Customer Name:		Gallien-Krueger		Current Rev #:		A1		New ECO Rev #:		A2	
Model:		Backline 250, 600, 115 Combo,		Distribute To:				Page:		1 Of: 2	
Assembly Description:		and 210 Combo		Originator:		Enrique Hernandez					
Assembly Numbers:		206-0181-A		Approved by:							
				Effective Date:		2/15/2005					
Effective				Document Update				Date		Initials	
<input checked="" type="checkbox"/>	All in Process	<input checked="" type="checkbox"/>	Next Buy	<input type="checkbox"/>	Artwork						
<input type="checkbox"/>	All in Service	<input checked="" type="checkbox"/>	Next Production Run	<input type="checkbox"/>	Assembly Dwg.						
<input checked="" type="checkbox"/>	All in Stock	<input type="checkbox"/>		<input type="checkbox"/>	Board Artwork						
Beginning Serial Number:				<input checked="" type="checkbox"/>	BOM						Noli
Reason For Change				<input type="checkbox"/>	Control Form						
Pre-Amp revoiced to sound more like the 400RB-IV.				<input checked="" type="checkbox"/>	Costing						TC

TITLE: BACKLINE 115 PREAMP
DRAWING NO: 406-0181-A
PART NO: 206-0181-A
REV: A2
COMPANY: GALLIEN-KRUEGER
FILENAME: 6181A.SCH

Customer Name:		Gallien-Krueger		Current Rev #:	A2	New ECO Rev #:	A3		
Model

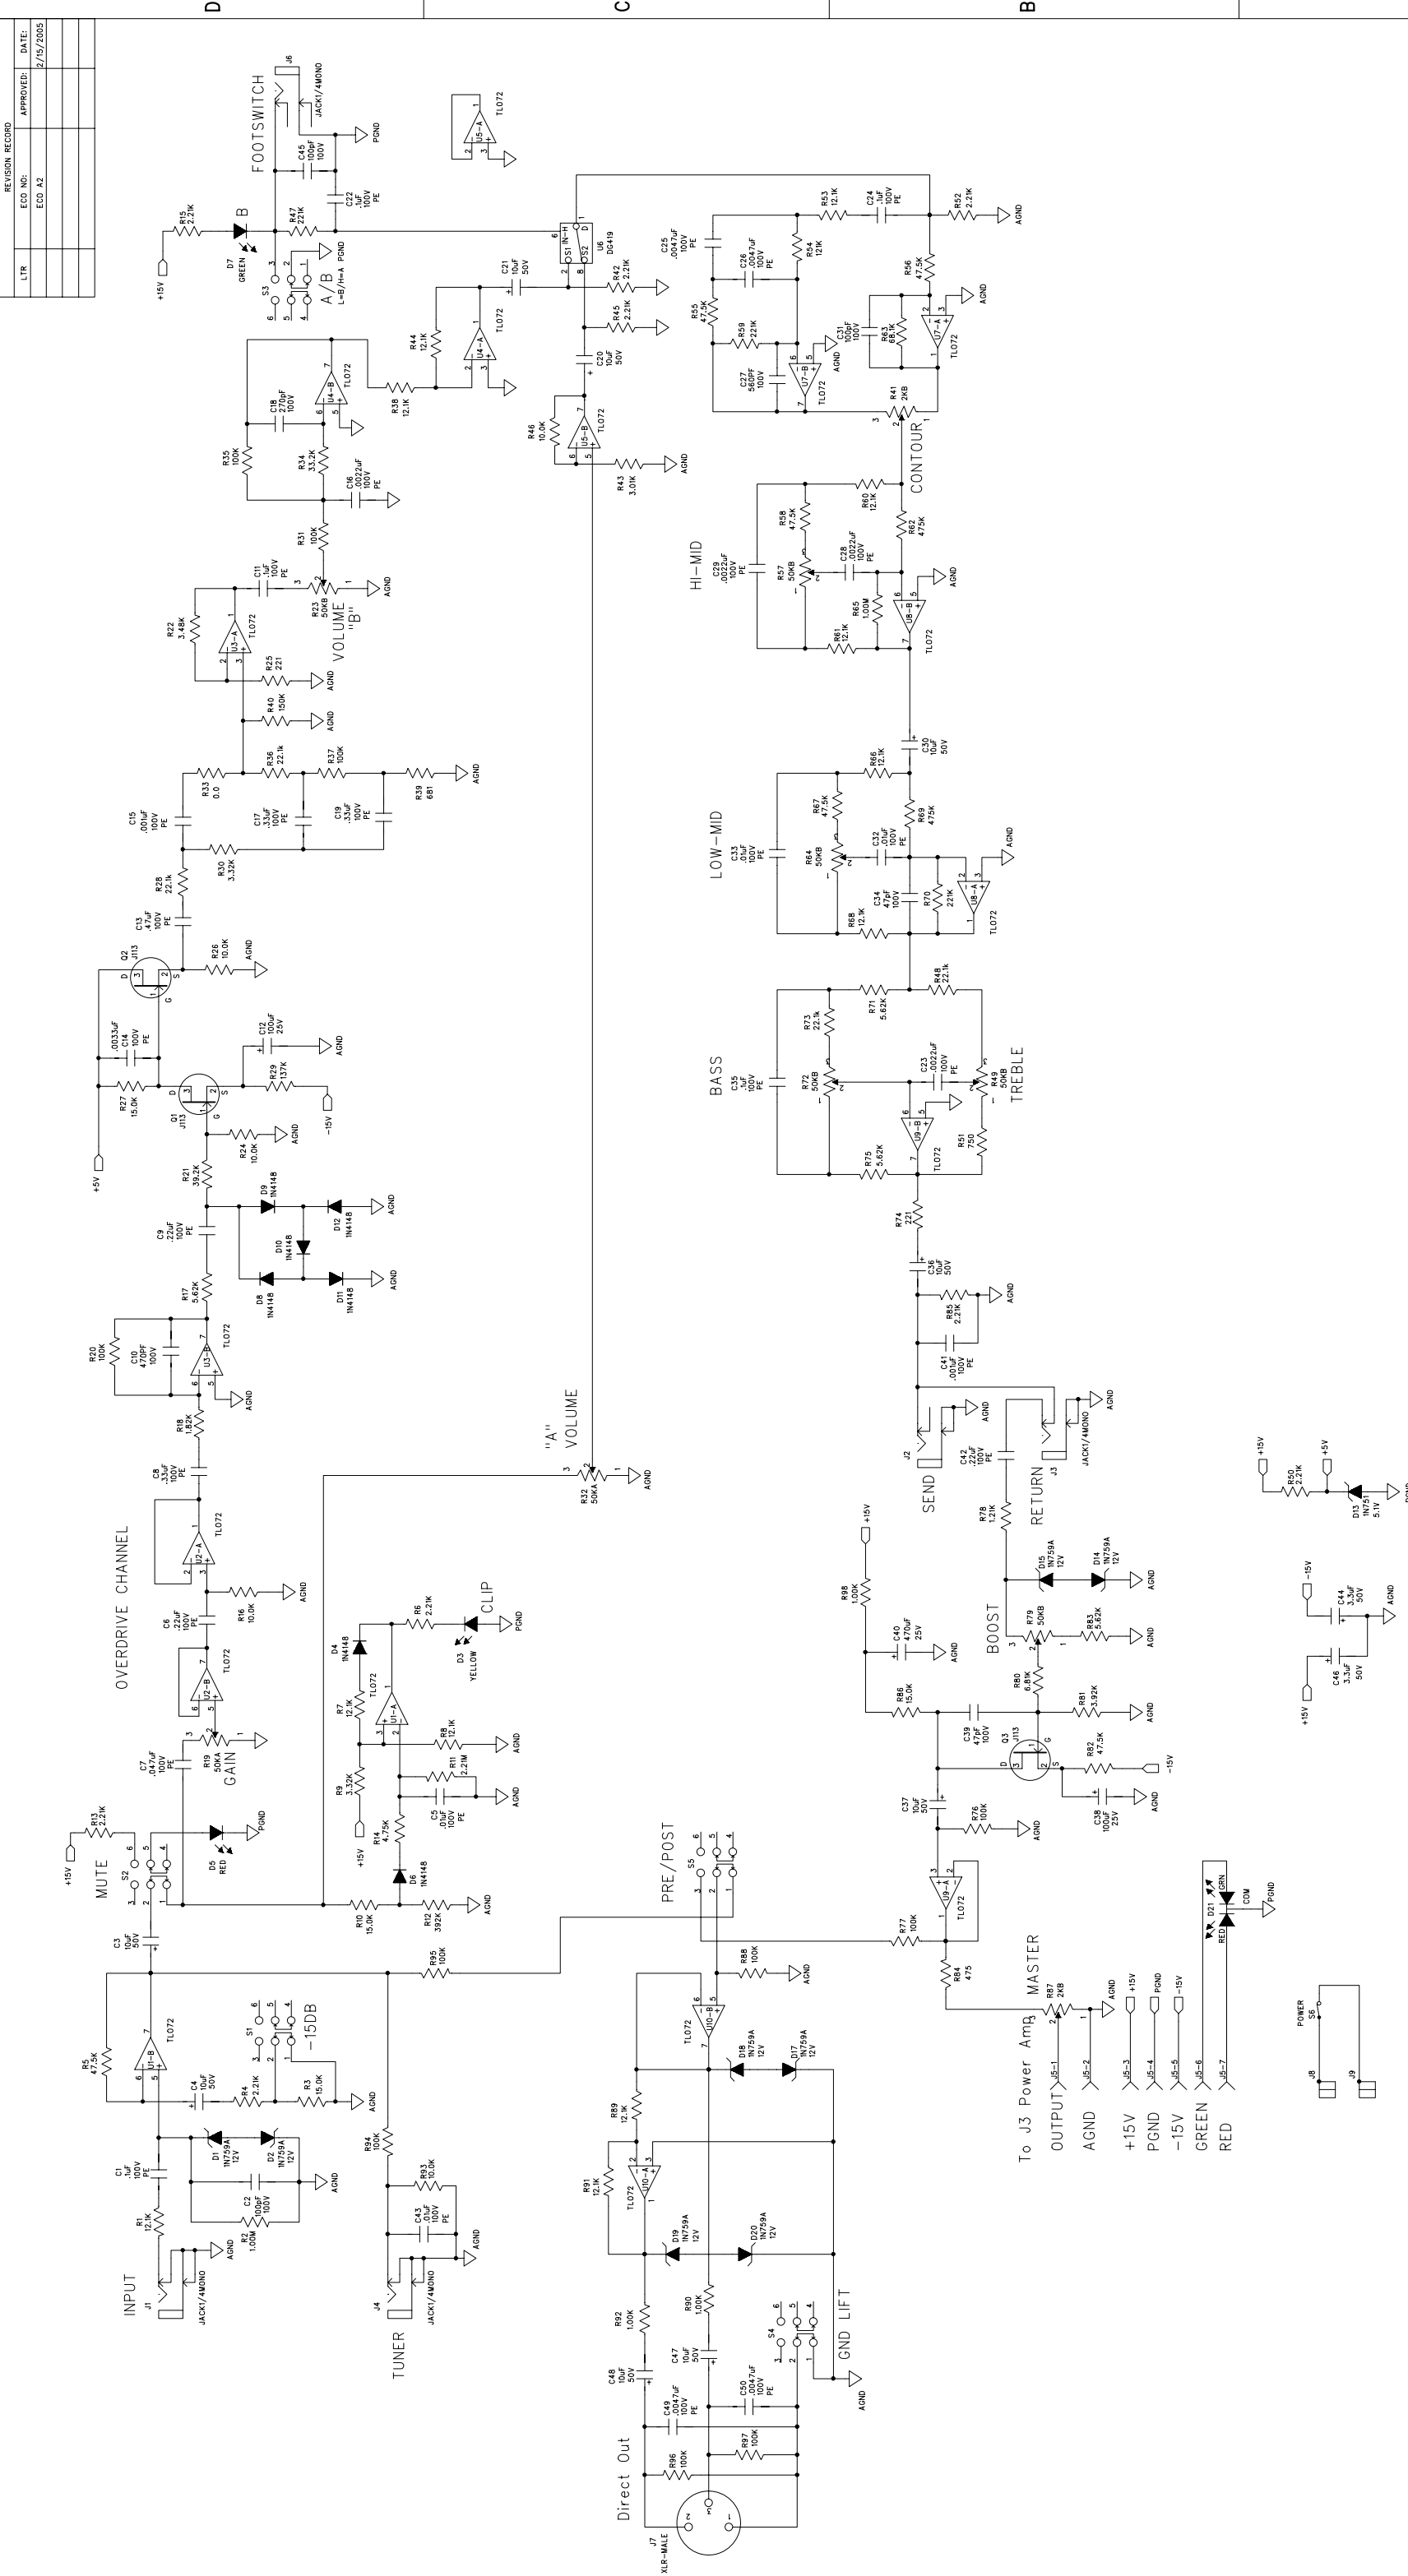
<input checked="" type="checkbox"/>	Incoming Q.C.						
				<input type="checkbox"/>	Planning						
				<input checked="" type="checkbox"/>	Production Eng.						
				<input checked="" type="checkbox"/>	Purchasing						
				<input type="checkbox"/>	Q.A.						
				<input type="checkbox"/>	Receiving						
				<input type="checkbox"/>	Service						
				<input type="checkbox"/>	Test						
				<input type="checkbox"/>	Vendor						
				<input type="checkbox"/>							
				<input type="checkbox"/>							
<input type="checkbox"/>	Continued on ECO Supplement Page			<input checked="" type="checkbox"/>	Drawing(s) attached						
Part Number	Description	Parts Added		Parts Deleted							
		Qty	Ref. Designator	Qty	Ref. Designator						
060-5622-0	1/8W, 5.62K			1	R48						
060-5622-0	1/8W, 5.62K			1	R51

1. Changed resistor R48 from 5.62K to 22.1K.
 2. Changed resistor R51 from 5.62K to 20K.
 3. Changed resistor R52 from 47.5K to 22.1K.
 4. Changed resistor R53 from 47.5K to 68.1K.
 5. Changed resistor R54 from 47.5K to 22.1K.
 6. Changed resistor R55 from 47.5K to 22.1K.

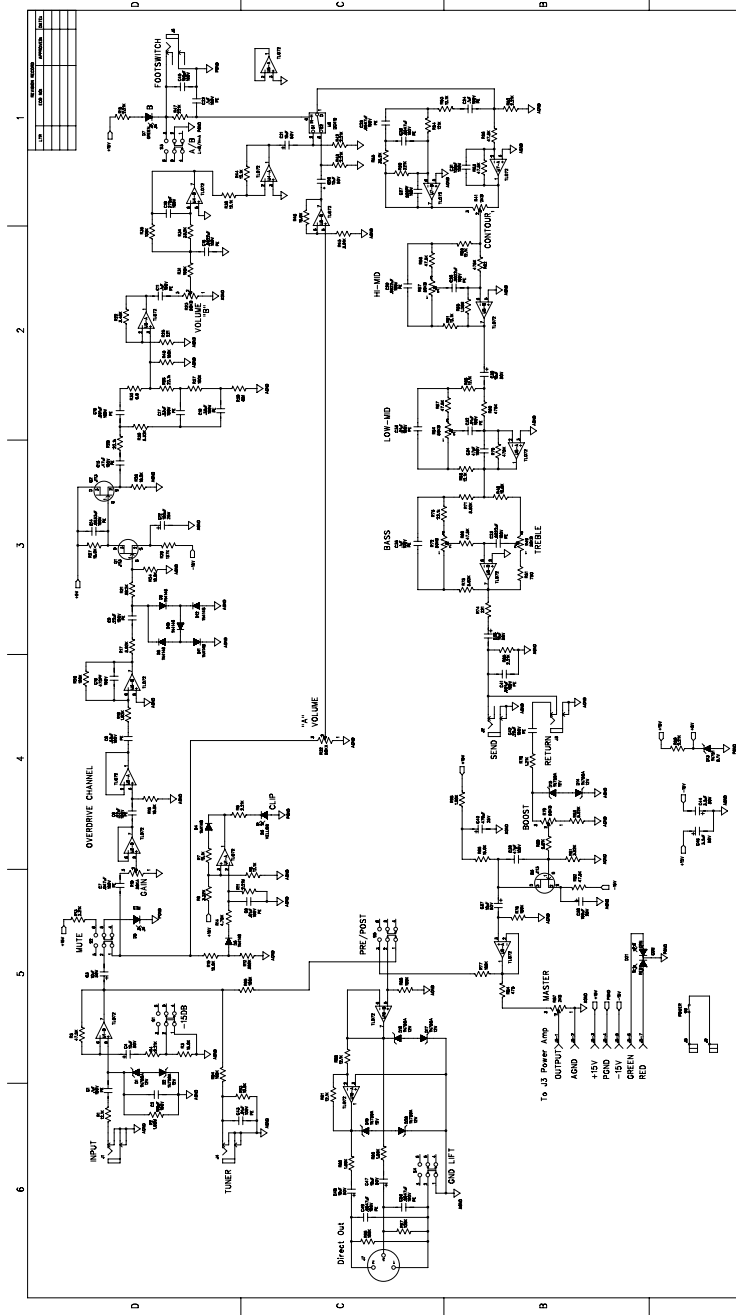
<input checked="" type="checkbox"/>	Incoming Q.C.				
Add a 47.5K resistor as well to bass and treble circuit that is missing, and should be there, it is designated R99 on the schematic 206-0181-A3.				<input type="checkbox"/>	Planning				
				<input checked="" type="checkbox"/>	Production Eng.				
				<input checked="" type="checkbox"/>	Purchasing				
				<input type="checkbox"/>	Q.A.				
				<input type="checkbox"/>	Receiving				
				<input type="checkbox"/>	Service				
				<input type="checkbox"/>	Test				
				<input type="checkbox"/>	Vendor				
				<input type="checkbox"/>					
				<input type="checkbox"/>					
<input type="checkbox"/>	Continued on ECO Supplement Page			<input checked="" type="checkbox"/>	Drawing(s) attached				
Part Number	Description	Parts Added		Parts Deleted		Qty	Ref. Designator	Qty	Ref. Designator
		Qty	Ref. Designator	Qty	Ref. Designator				
060-2213-0	1/8W, 22.1K					1	R48

TITLE: BACKLINE 115 PREAMP
DRAWING NO: 406-0181-A4
PART NO: 206-0181-A4
COMPANY: GALLIEN-KRUEGER
RELEASED: 2/1/03
FILENAME: 6181A4.SCH

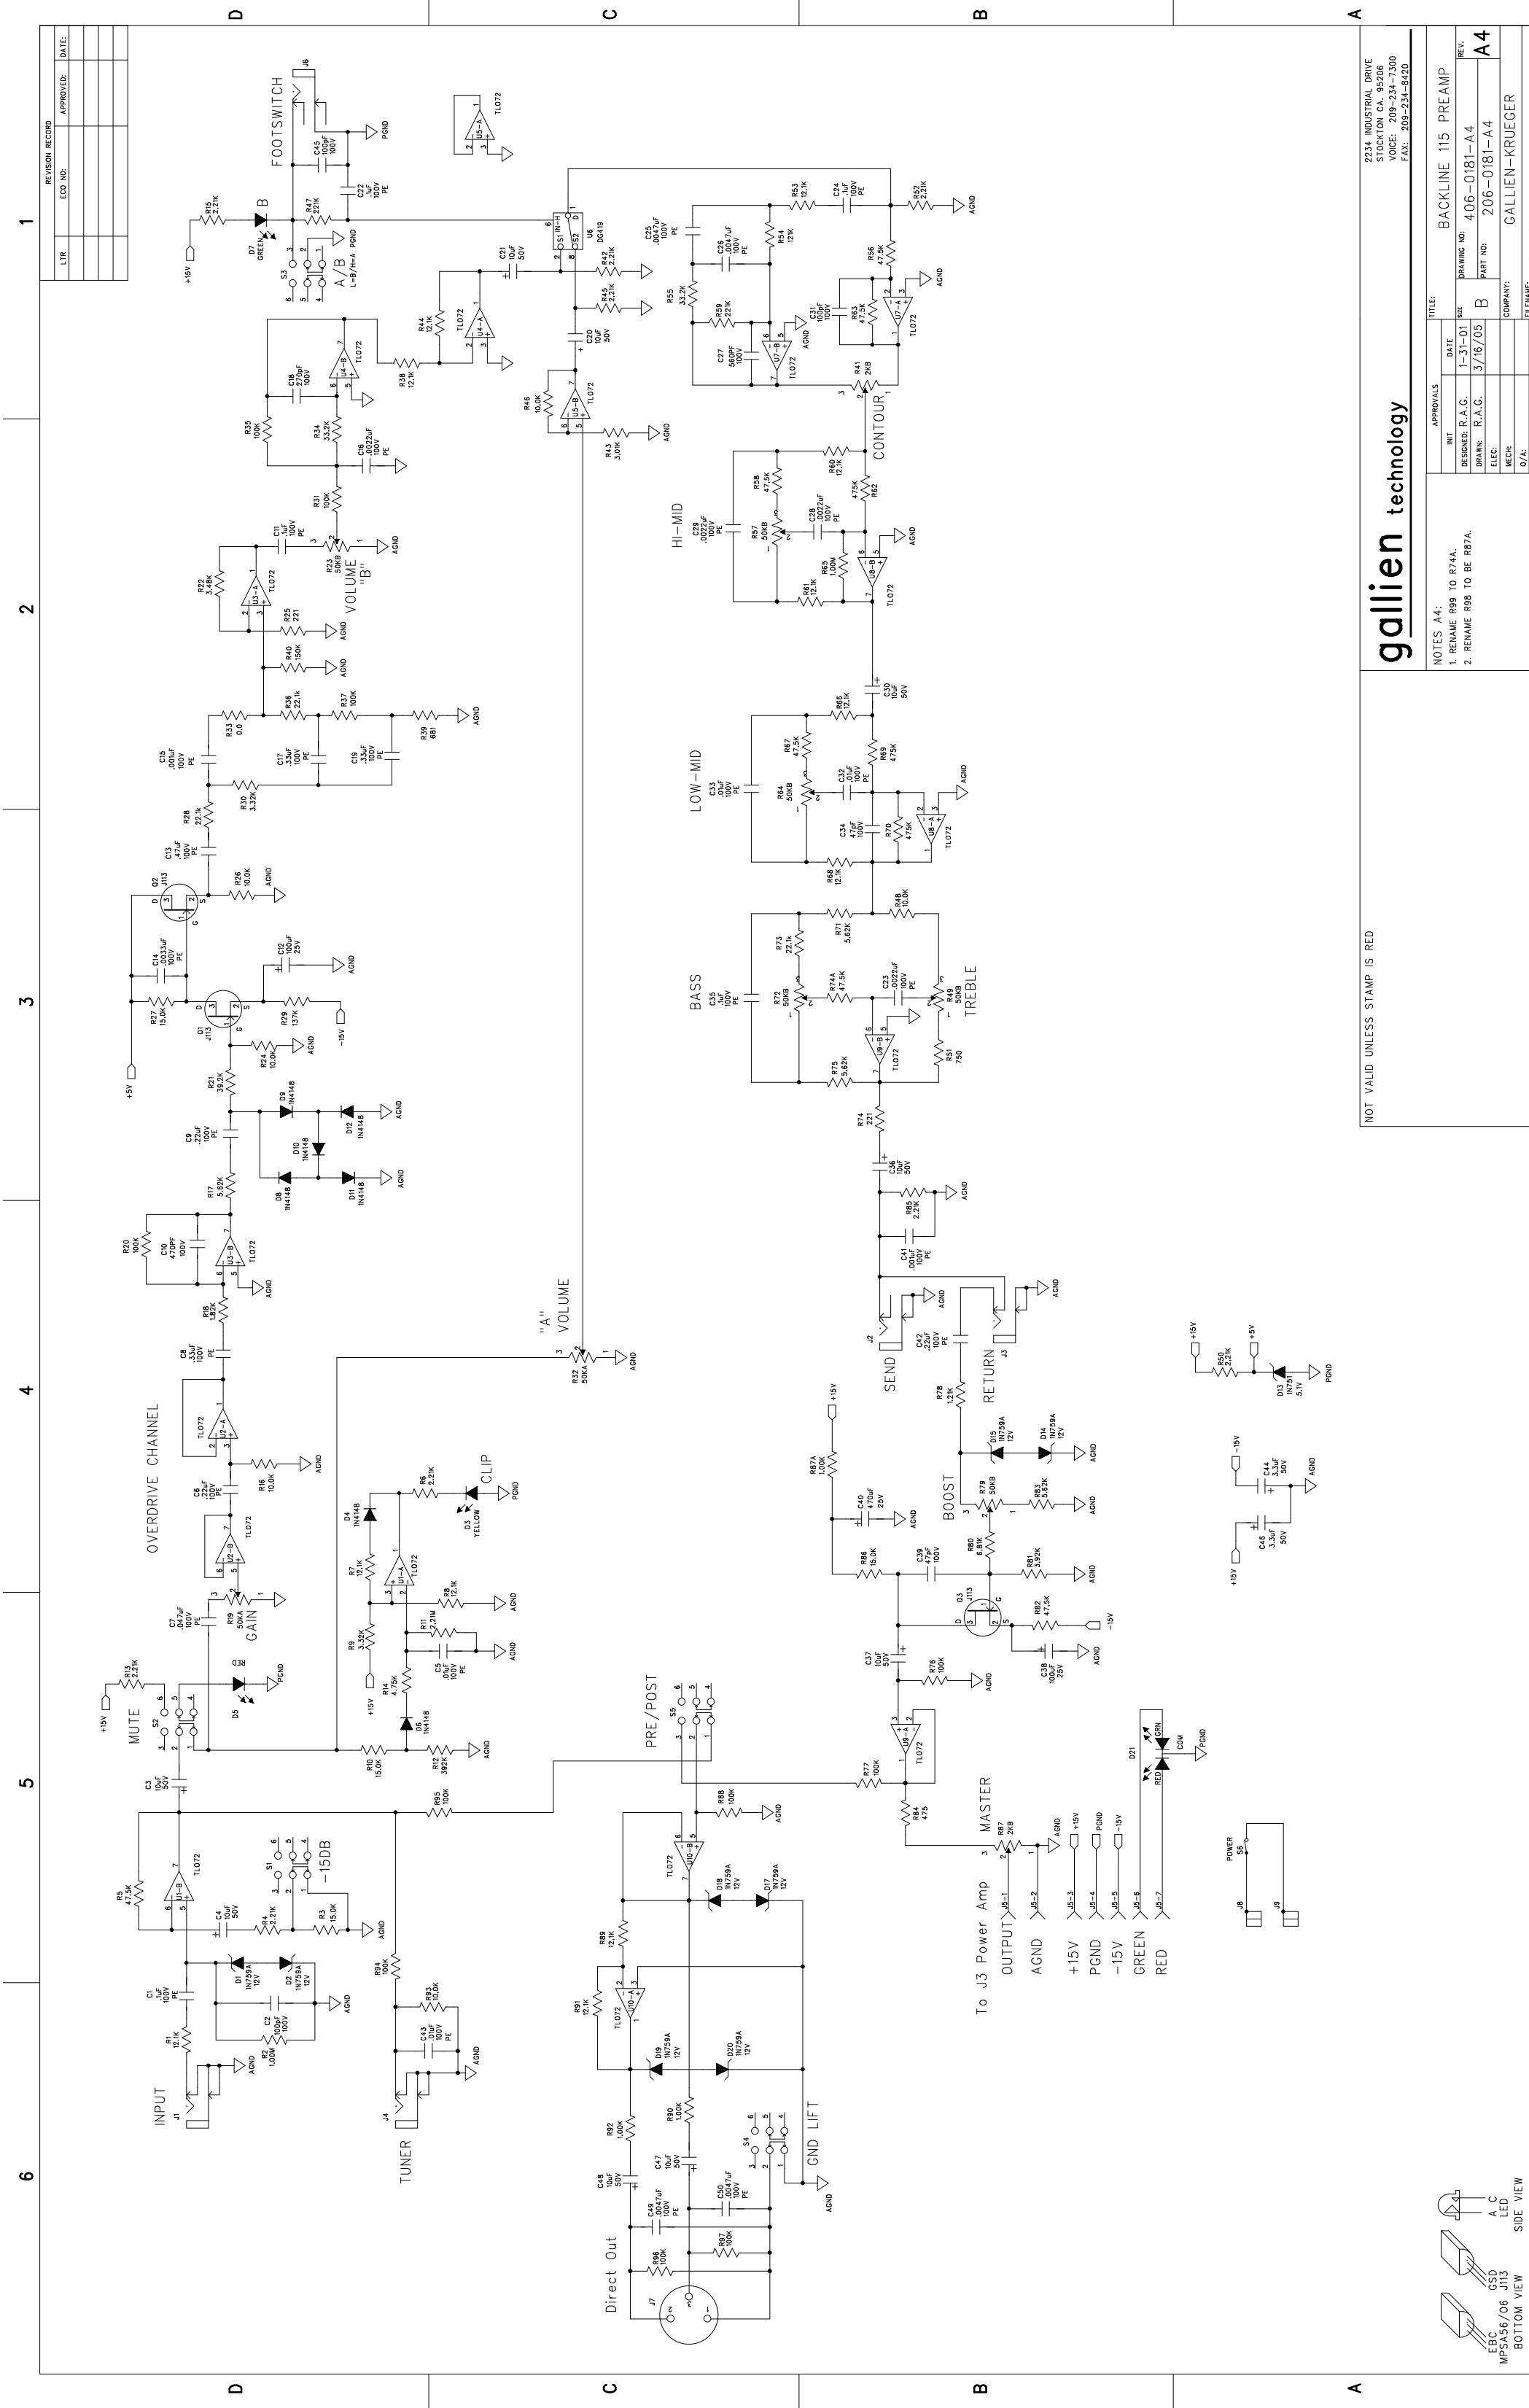
<input type="checkbox"/>	Fab Drawing						
				<input type="checkbox"/>	Inspection Proc.						
				<input checked="" type="checkbox"/>	Part Master File						Noli
				<input checked="" type="checkbox"/>	Schematic						RAG
				<input type="checkbox"/>	Service Manual						
				<input type="checkbox"/>	Test Procedure						
				<input type="checkbox"/>							
				<input type="checkbox"/>							
				Other Affected Assemblies							
				209-0180-A, 303-0180-A,							
				303-1180-A, 303-2180-A							
<input type="checkbox"/>	Continued on ECO Supplement Page										
Description Of Change				Distribution				Date		Initials	
Update BOM.				<input type="checkbox"/>	Accounting						
Update Part Master File.				<input type="checkbox"/>	Assembly						
Updated Artwork 145-0181-A4.				<input checked="" type="checkbox"/>	Customer						
Resistor R98 changed to R87A, and resistor R99 changed to R74A.				<input checked="" type="checkbox"/>	Engineering

NOTES: A4:
1. RENAME R98 TO R74A.
2. RENAME R98 TO BE R74A.

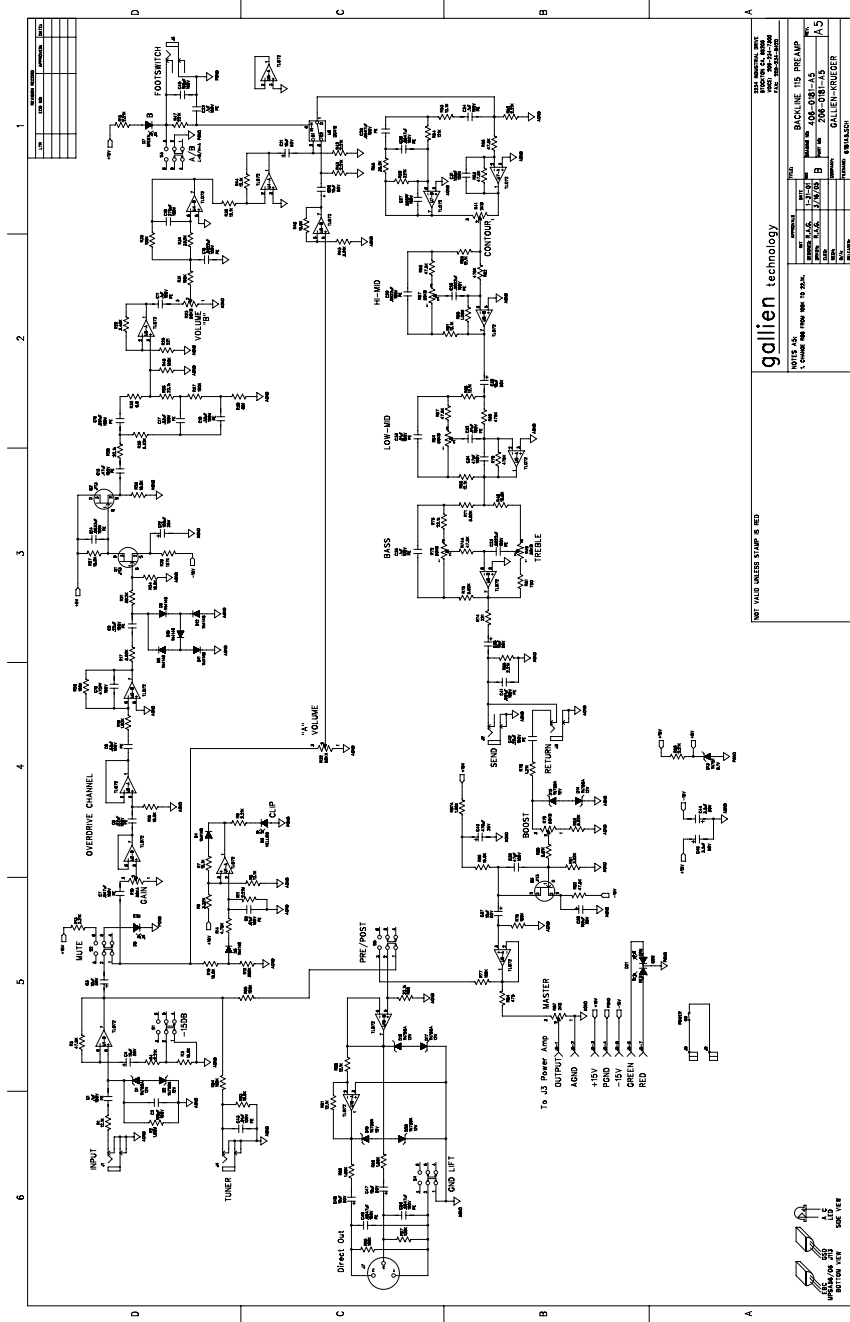
Customer Name:		Gallien-Krueger		Current Rev #:		A4		New ECO Rev #:		A5	
Model:		Backline 250, 600, 115 Combo, and 210 Combo		Distribute To:				Page:		1 Of: 2	
Assembly Description:		preamp board		Originator:		Enrique Hernandez					
Assembly Numbers:		206-0181-A		Approved by:							
				Effective Date:		12/15/2005					
Effective				Document Update				Date		Initials	
<input checked="" type="checkbox"/>	All in Process	<input checked="" type="checkbox"/>	Next Buy	<input type="checkbox"/>	Artwork						
<input checked="" type="checkbox"/>	All in Service	<input checked="" type="checkbox"/>	Next Production Run	<input type="checkbox"/>	Assembly Dwg.						
<input type="checkbox"/>	All in Stock	<input type="checkbox"/>		<input type="checkbox"/>	Board Artwork						
Beginning Serial Number:				<input checked="" type="checkbox"/>	BOM						Noli
Reason For Change				<input type="checkbox"/>	Control Form						
DI output too hot, need to decrease DI level to match the level of the 700RB-II/1001RB-II pre-amp when level knob is set to max.				<input checked="" type="checkbox"/>	Costing						TC
